APPEAL SUMMARY

Appeal ID: 26337

Building/Business Name: OHSU Elks Children's Eye Clinic **Fire Sprinklers:** Yes - Throughout

LUR or Permit Application No.: 18-164033-CO

B1 LIFE SAFETY PLAN - LEVEL 2

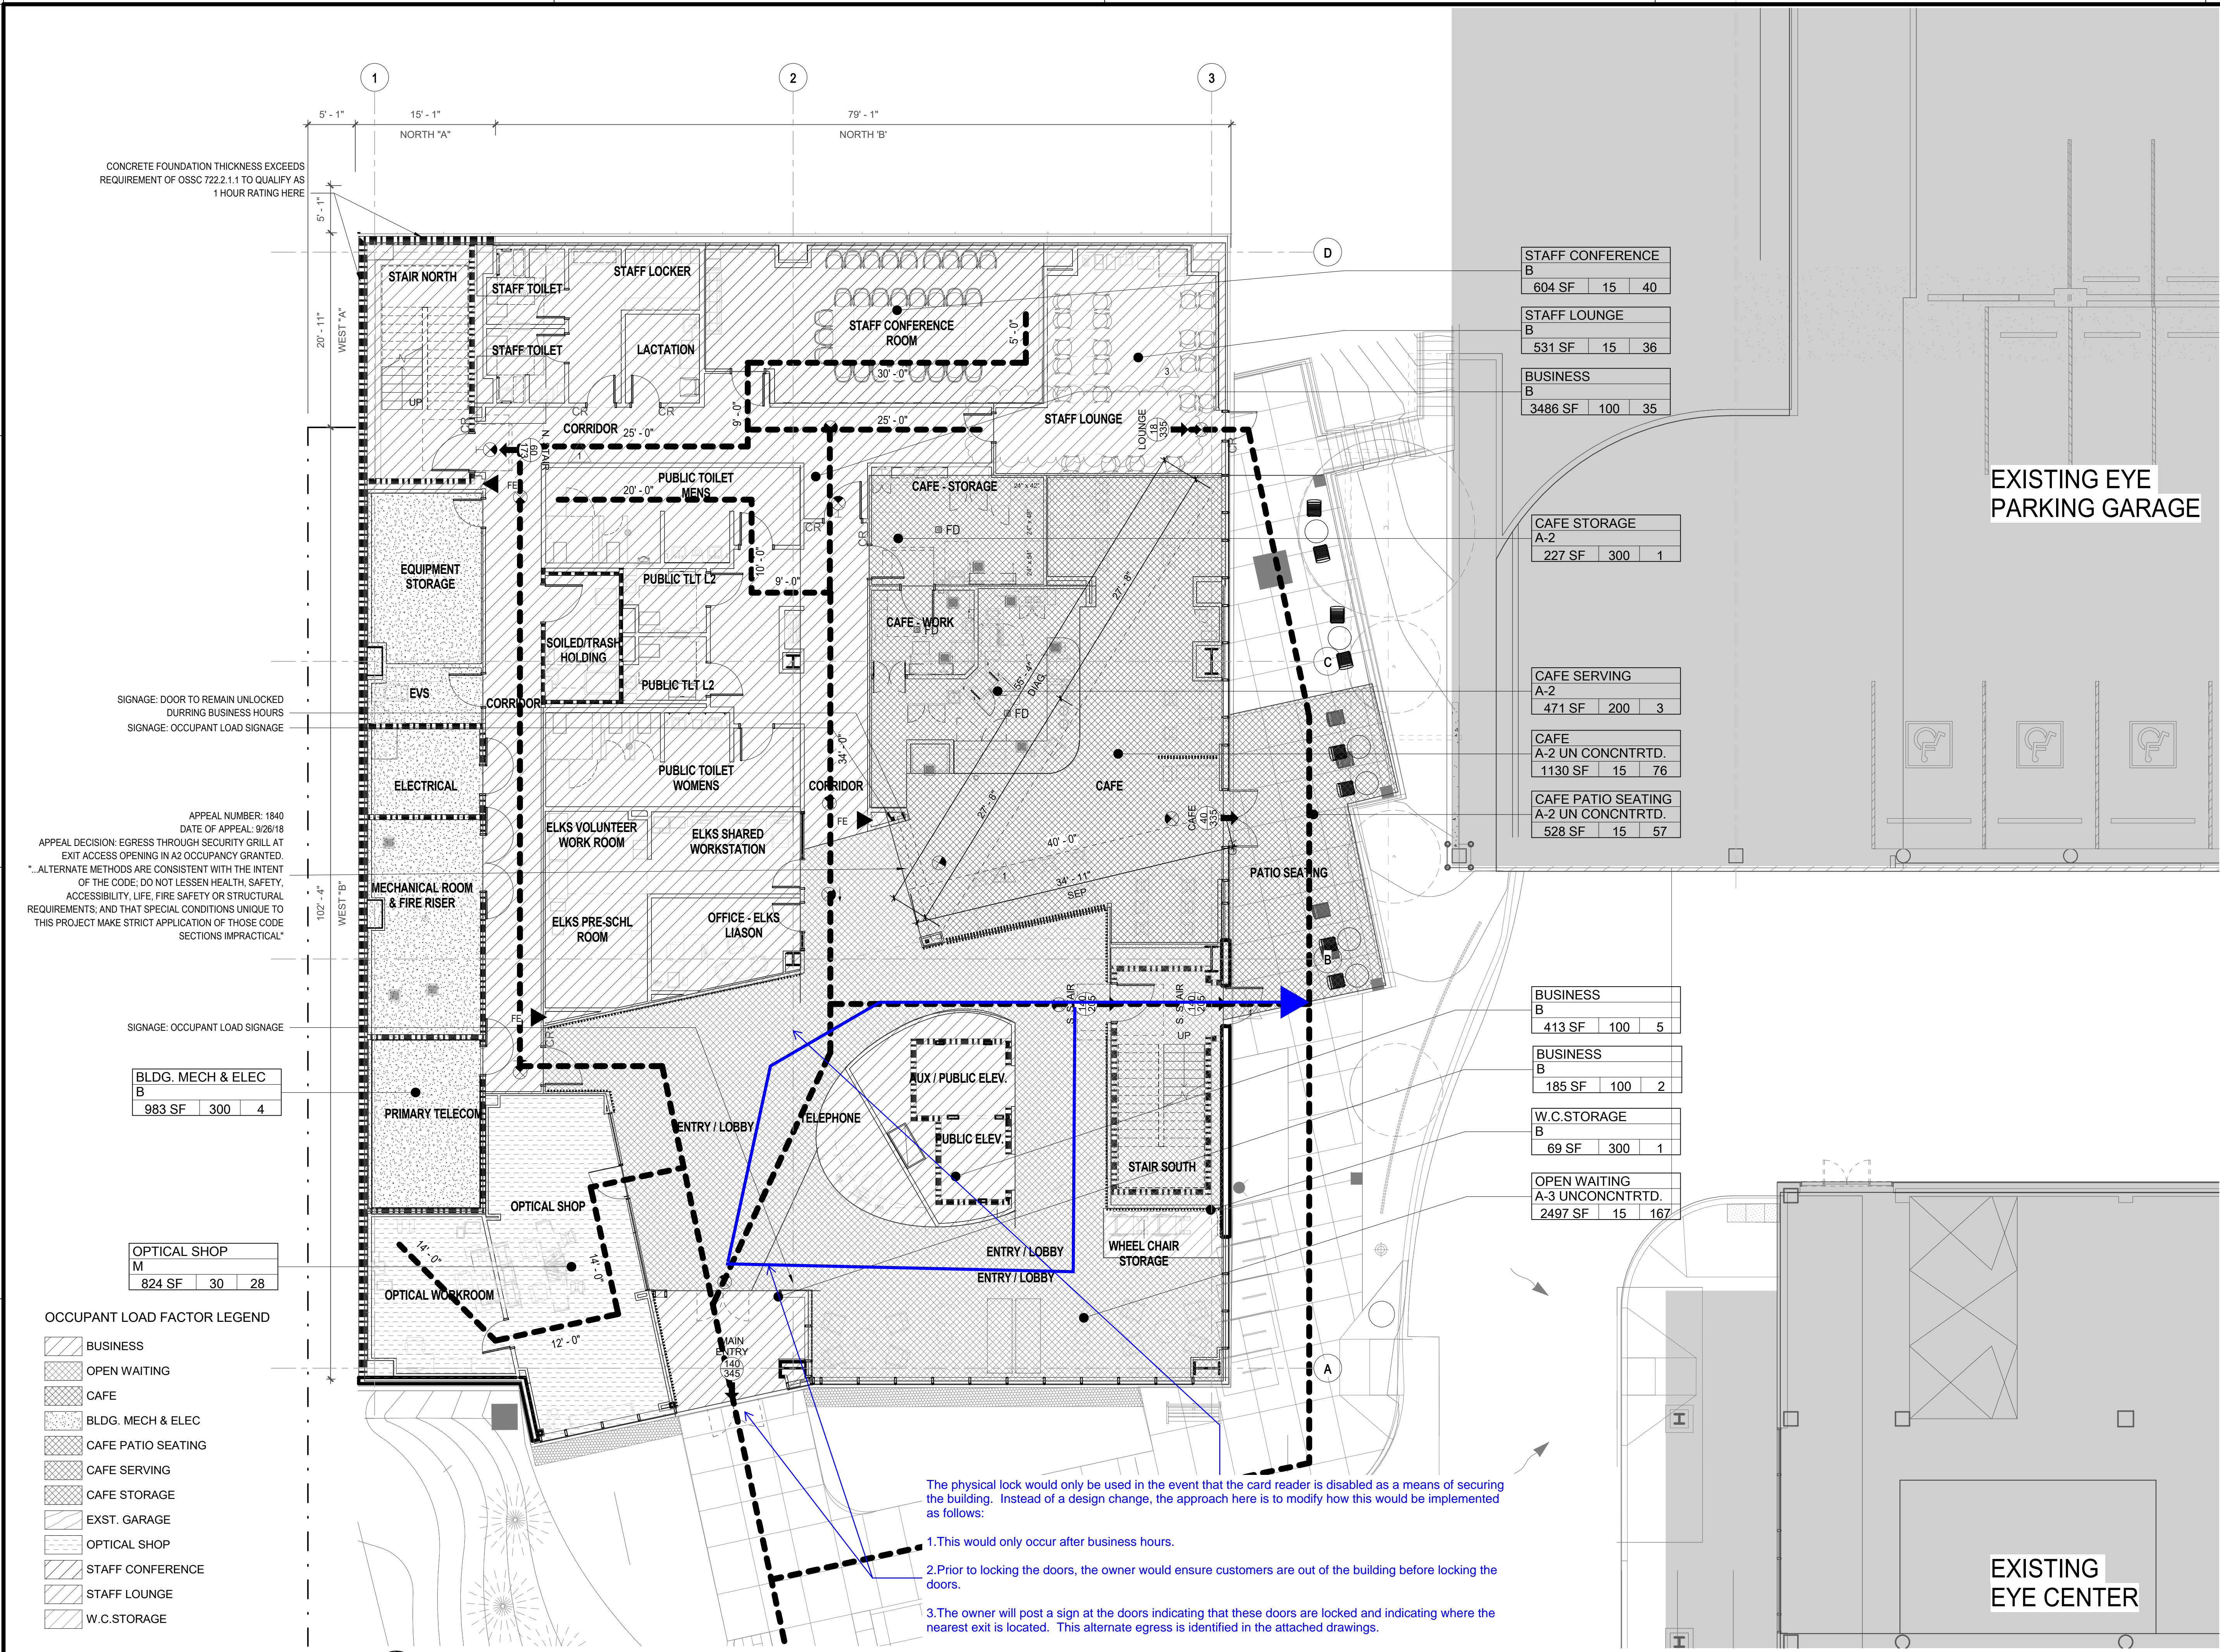
Provide indicator on keyed cylinder lock at front entry doors. Current lock has no indicator.

The owner will post a sign at the doors indicating that these doors are locked and indicating where the nearest exit is located. This alternate egress is identified in the attached drawings.

Omission of indicator on keyed cylinder lock at front entry doors: Granted as proposed.
